# 1964 Corvette: Engineering Service Letter: Muncie Four Speed Transmission Design Change

# ENGINEERING SERVICE LETTER

**SUBJECT:** MUNCIE FOUR SPEED TRANSMISSION - 1964 DESIGN  
CHANGE AFFECTING PAST MODELS SERVICE REPLACEMENT  
AND A FIELD FIX IF REQUIRED

**DATE** 8-20-63  
**SECTION** 7  
**MODEL** RPO M20 800-  
1200-1600-1800 & RPO  
M21-1200-1600-1800-1963

For a comparison between the new and old design in the transmission area affected see attached sketch. Old parts indicated by an asterisk (\*) are no longer required as part of revised design.

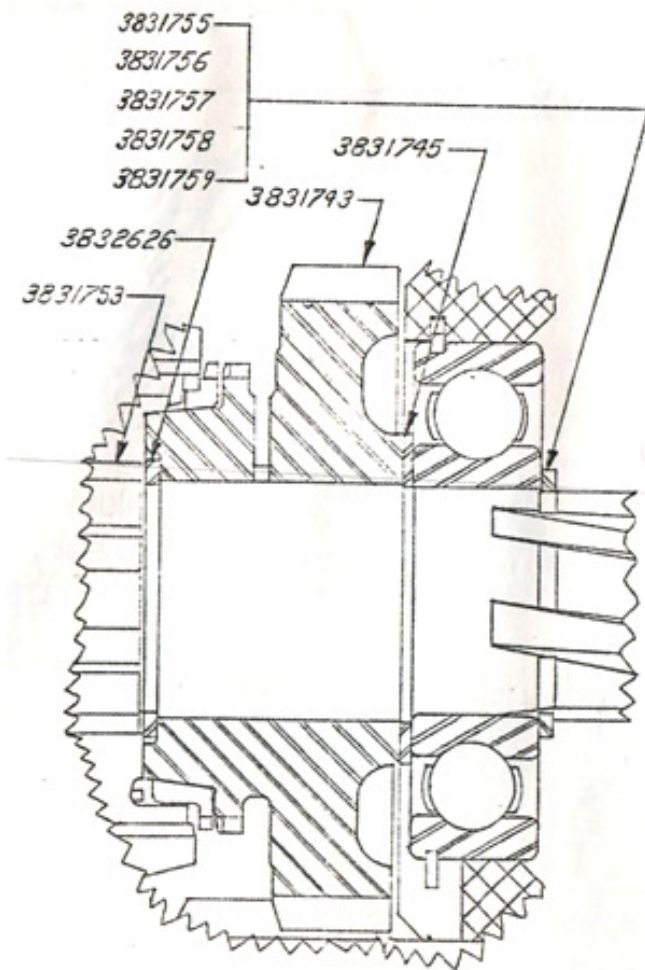
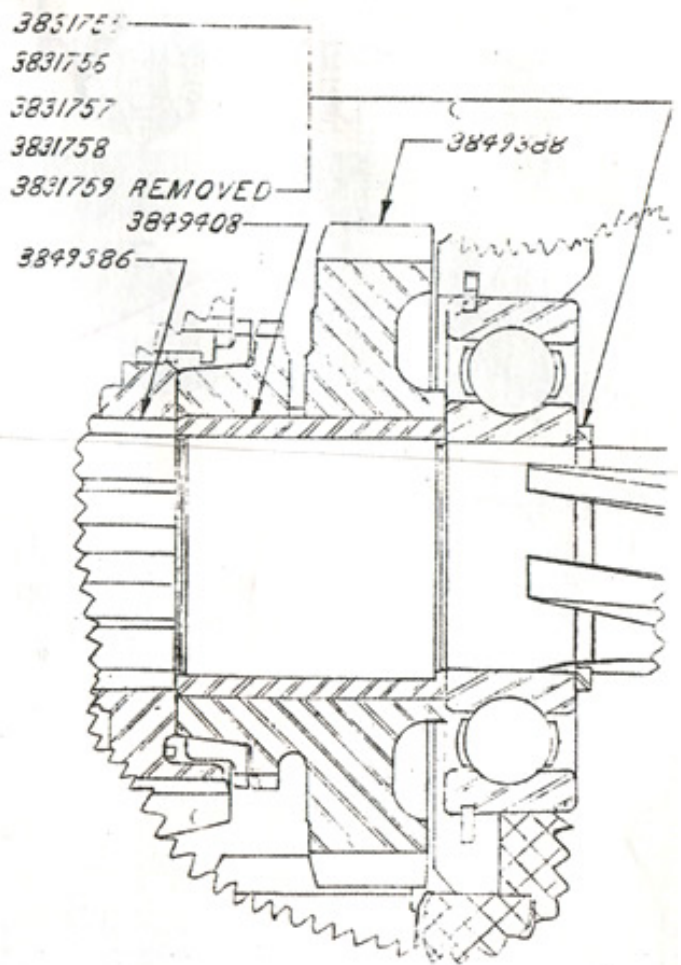
A design change is being introduced for start of production 1964 on subject transmission which includes a new transmission mainshaft, first speed gear, and first speed gear sleeve. The new parts are not interchangeable as details for service replacement on past models. The reasons for the changes are to provide positive first speed gear end clearance, and also to eliminate the possibility of seizure between the inside diameter of the first speed gear and the matching mainshaft outside diameter by use of a new sleeve. The seizure has been reported from the field in several instances at relatively low mileage, and the new parts indicated above are to be used for past model service replacement if this type of transmission failure is noted.

<u>New Parts</u>	<u>Old Parts</u>	<u>Name</u>	<u>Production Disposition</u>
3849386	3831753	Shaft - Trans. Main	Cancelled & Repl. by 3849386
3849388	3831743	Gear - First Speed	Cancelled & Repl. by 3849388
3849408	-----	Sleeve - First Speed Gear	New
-----	*3831745	Washer - 1st Speed Gear Thrust	Cancelled & Not Replaced
-----	*3831759	Ring - Trans. Main Shaft Rear Brg. Retainer	Cancelled & Not Replaced
-----	*3832626	Ring - Trans. 1st & 2nd Synchronizer Retaining	Cancelled & Not Replaced

Approximately 20,000 total Muncie Transmissions of the first design will be built before this change is introduced.

From the viewpoint of excessive cost to the customer, if the combination of new parts was used for all past model service replacement, it was decided to maintain old stock.
